FAX	Alcatel Space Industries Herschel Planck project office OS/M/H Fax + 33 4 92 92 30 10 Tel Secretary: + 33 4 92 92 30 85	Nb pages 1/2
	Date 06/03/02	Référence H-P-ASPI-LT-1086

SPIRE cryo-harness internal overall shield

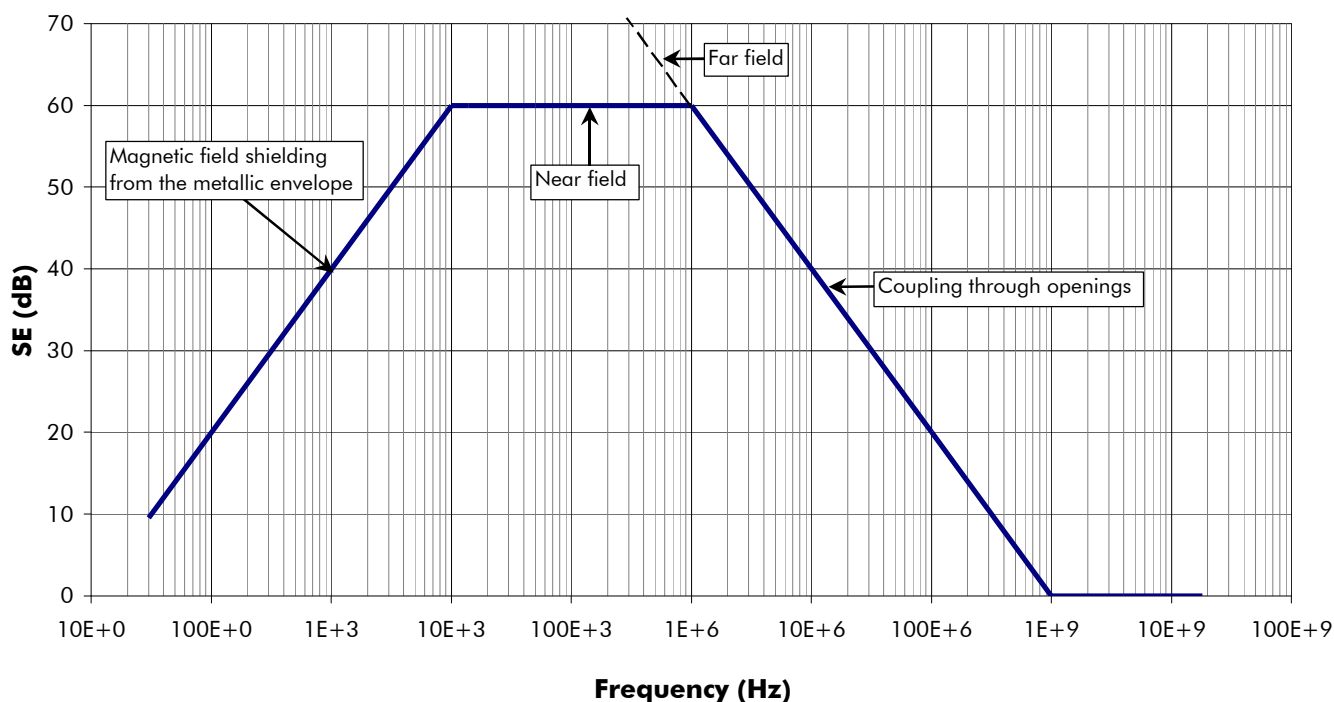
At the meeting held on the 13/02 at ESTEC it was decided that SPIRE **internal** cryo-harness overall shield (the "FPU Faraday shield") was **not** considered as the baseline for the PDR design.

The rationale can be summarised as follows :

- the sensitive links are already protected against low frequency EMI by other means (balanced differential links, analogue 0V grounded on one side only, individual shields grounded on one side only, etc.) + to some extent by the cryostat shielding efficiency
- this overall shielding, the way it is planned to be connected to SVM through cryo-harness wires cannot a priori be efficient at high frequency (roughly above 1 MHz), that is to say where the cryostat shielding efficiency is expected to decrease (cf. cryostat shielding efficiency mask next page, also cf. [Ref. 1] and [Ref. 2]), so there would be little extra EMC benefit to expect from it
- on the other hand, this overall shielding, the usefulness/implementation of which is doubtful, may have a significant impact on lifetime

However, in case the EMC tests on the HPLM EQM finally lead to the conclusion that an overshielding is actually necessary on SPIRE internal cryo-harness (i.e. high frequency susceptibility is found), one must evaluate this possible option, i.e :

- define what would be the characteristics of an internal overshielding efficient at high frequency (material, process, backshells, etc.)
- estimate its efficiency (ratio of interface noise pick-up with/without in dB)
- assess the impact of such an overshielding (lifetime, mass, etc.), and the feasibility/impacts of introducing it on the FM after the EQM EMC tests completion

In order to be prepared to such eventuality, Astrium is kindly requested to propose an assessment of these last 3 points.
